SUBJECT: Requests relief from certain requirements of ASME Section XI associated w/partial exams conducted during 1995 plant refueling outage ISI.

**VIRGINIA ELECTRIC AND POWER COMPANY**  
**SURRY POWER STATION UNIT 2**  
**INSERVICE INSPECTION PROGRAM RELIEF REQUESTS**

**Attachment 1**  
**Surry Power Station Unit 2**  
**ISI Examination Relief**

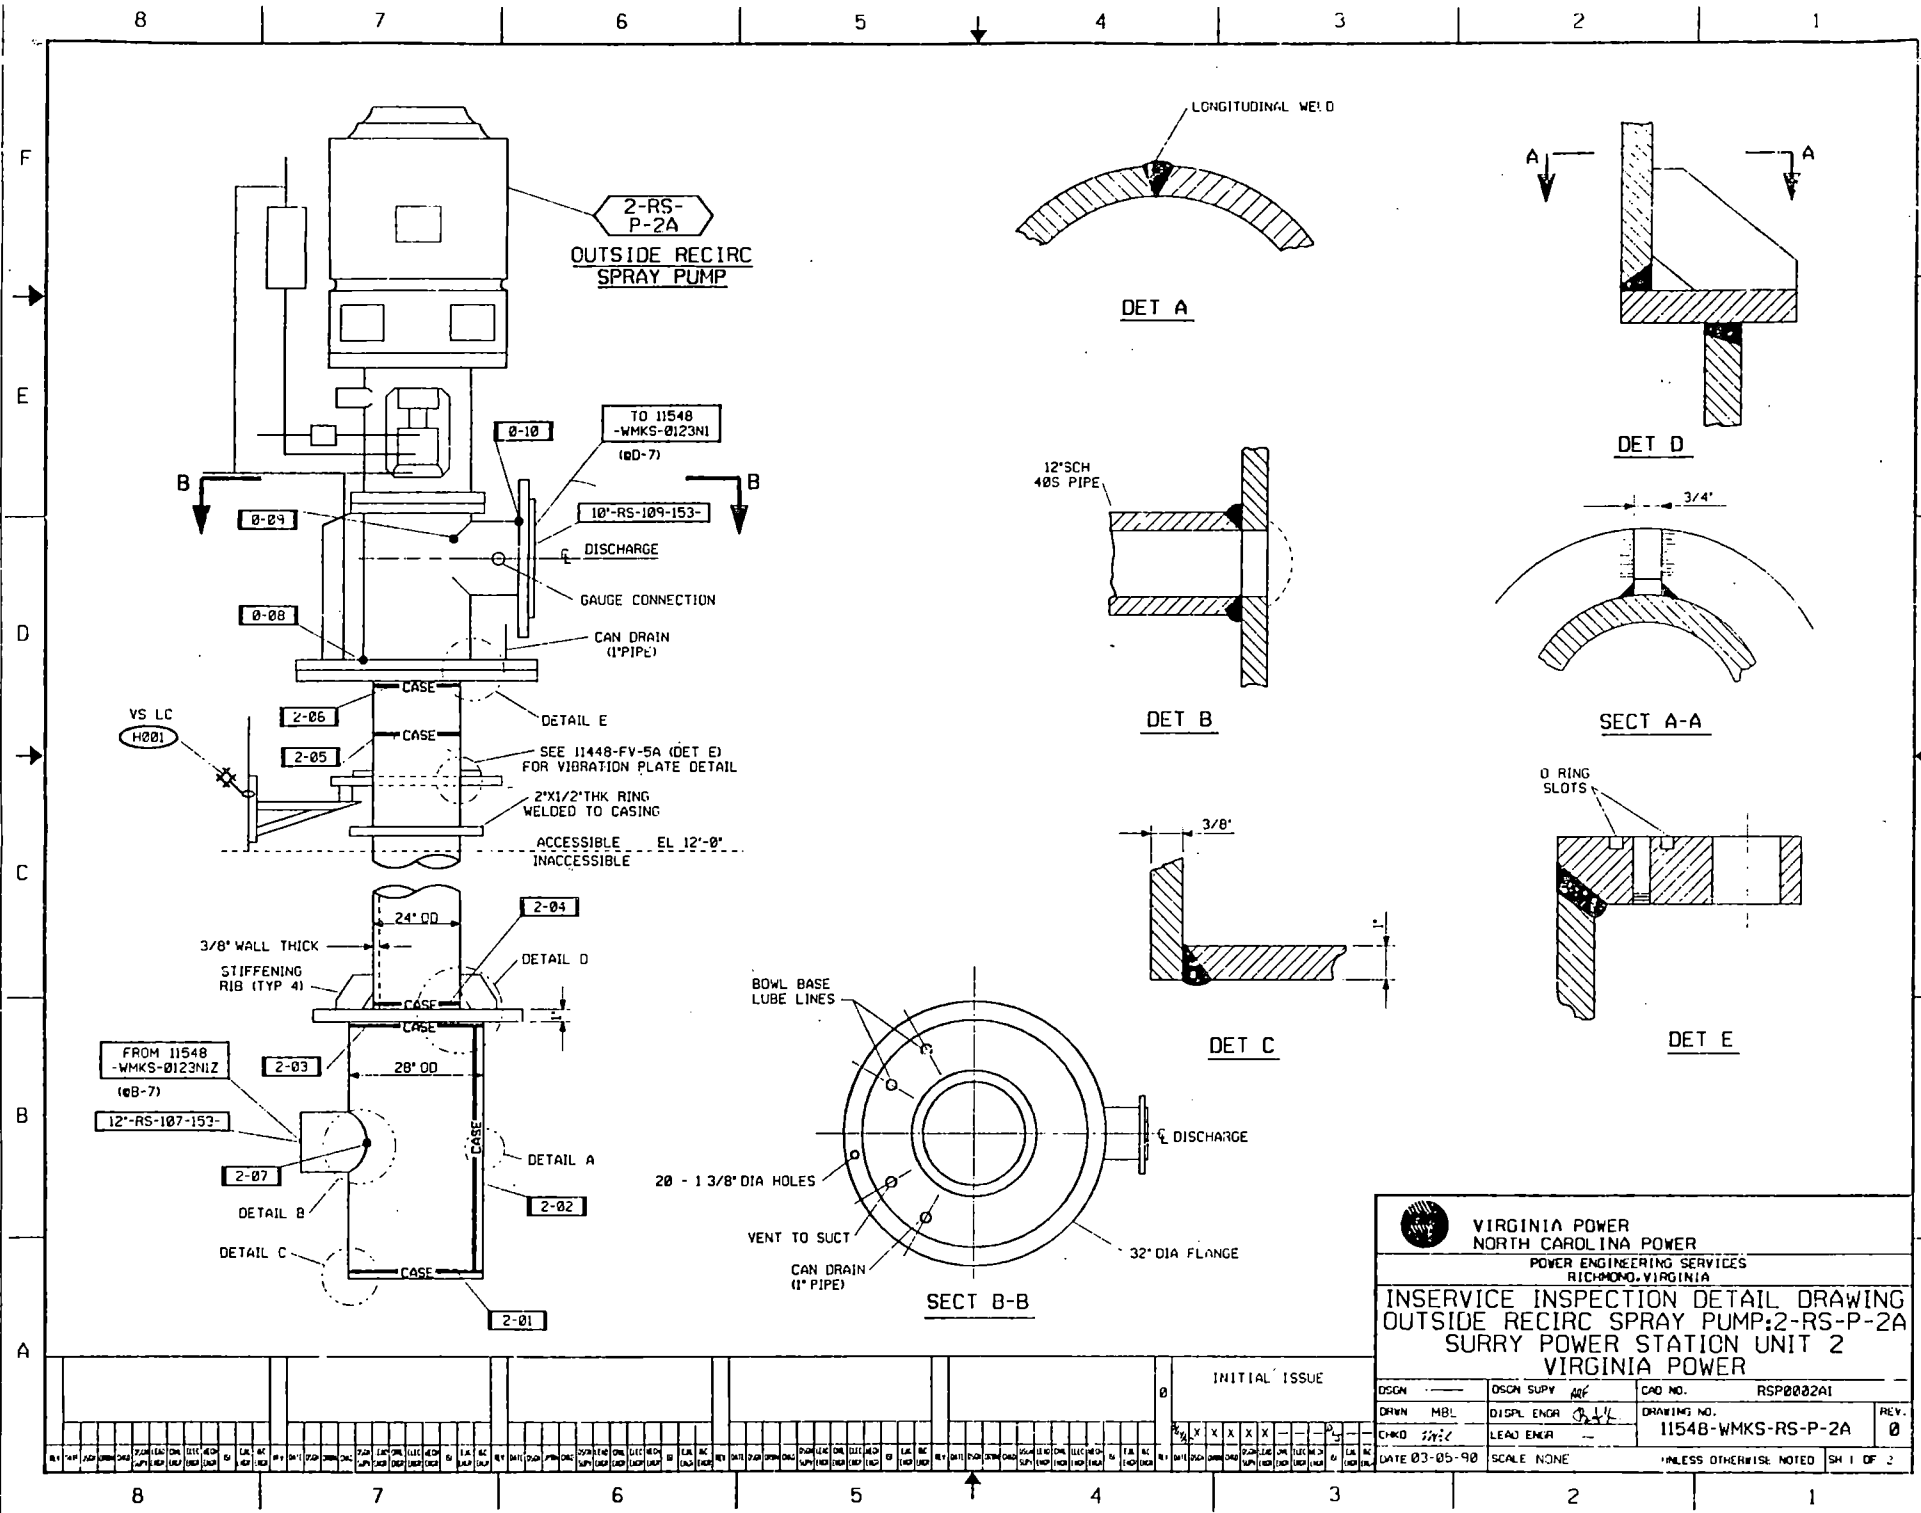
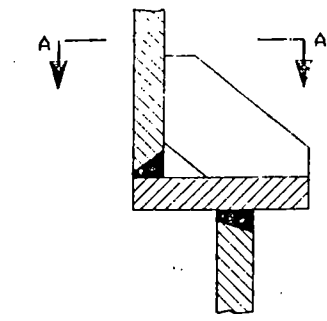
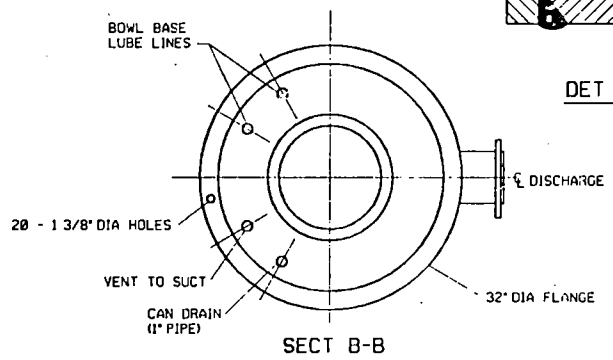
<u>Mark/Weld#</u>	<u>Drawing#</u>	<u>Class</u>
2-05	11548-WMKS-RS-P-2A	2
